Iceman SWD #1 Workover NOI

Iceman State SWD #1
660' FSL & 660' FWL, UL M, Sec. 17, T23S-R27E, Eddy County, NM
API # 30-015-44265

Action 257086

Operator: SOLARIS WATER MIDSTREAM, LLC 907 Tradewinds Blvd, Suite B Midland, TX 79706	OGRID: 371643
	Action Number: 257086
	Action Type: [C-103] NOI Workover (C-103G)

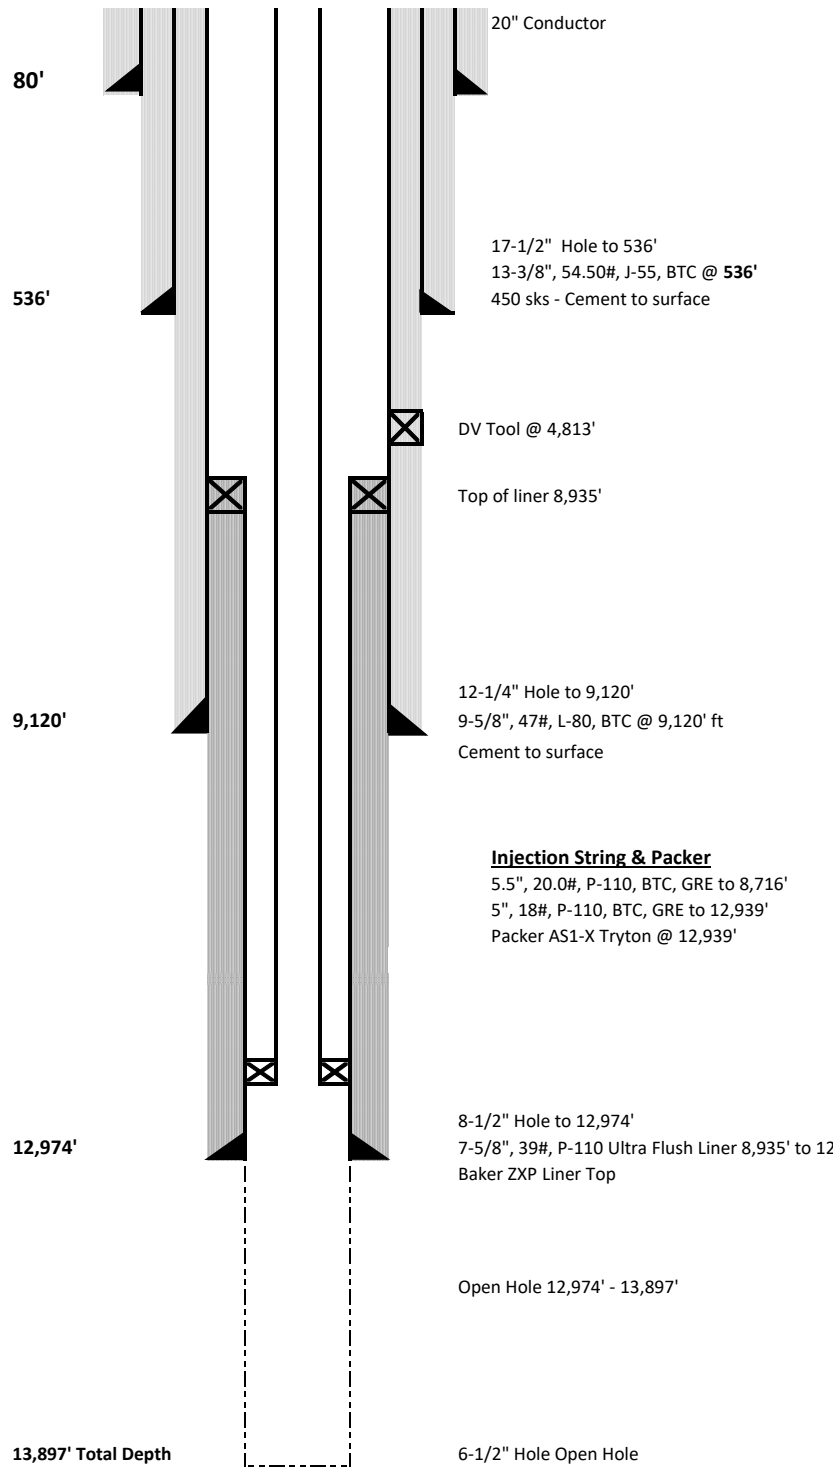
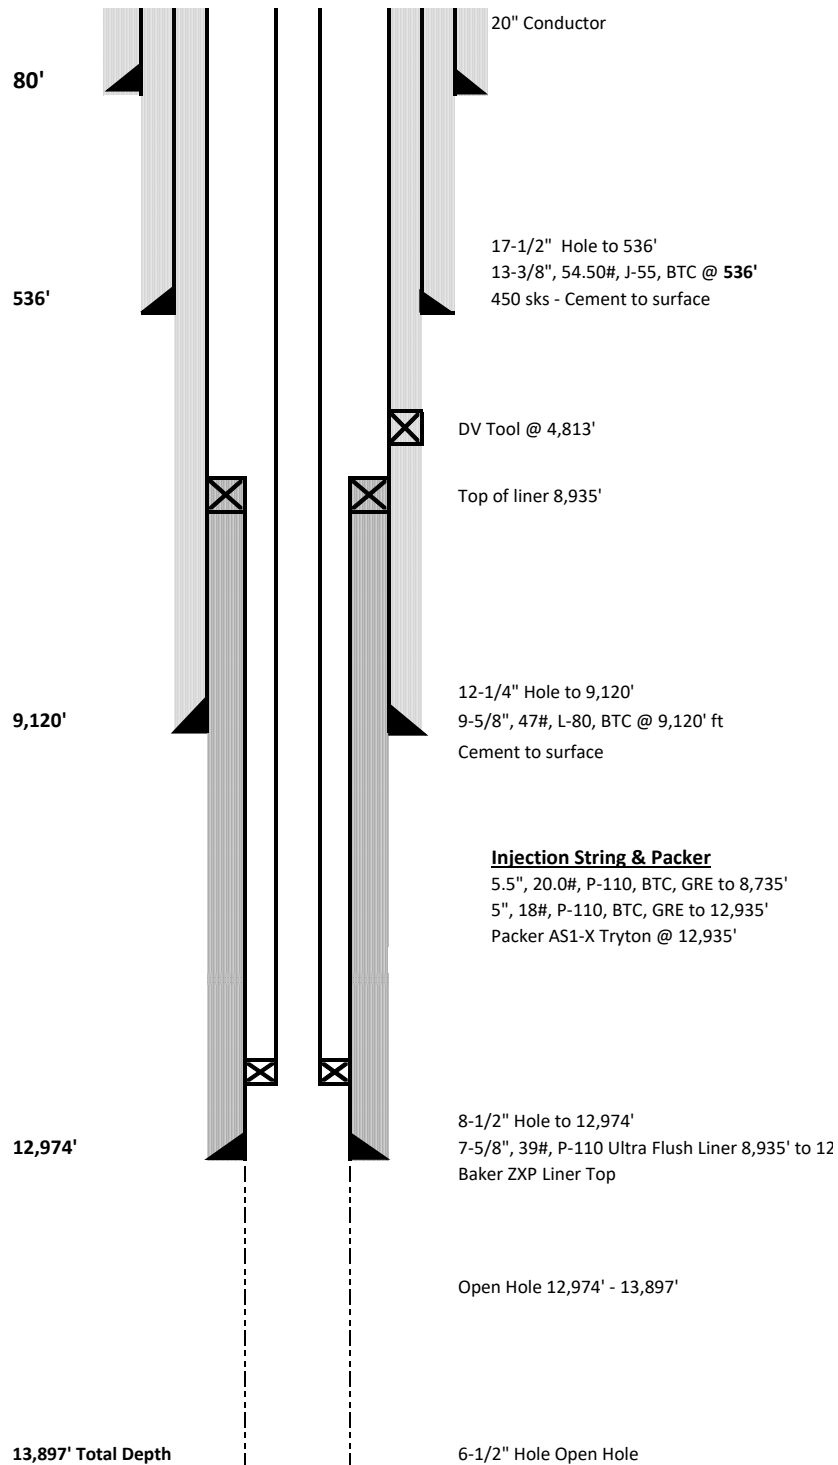
Created By	Condition	Condition Date
mgebremichael	The workover NOI has been approved. Please ensure that same size tubing as it is stipulated in the respective order be re-installed and packer is set at not more than 100 ft. of the top of the open hole. Please ensure that MIT is passed before resuming injection. If you have any questions, please reach out to UIC group.	8/24/2023
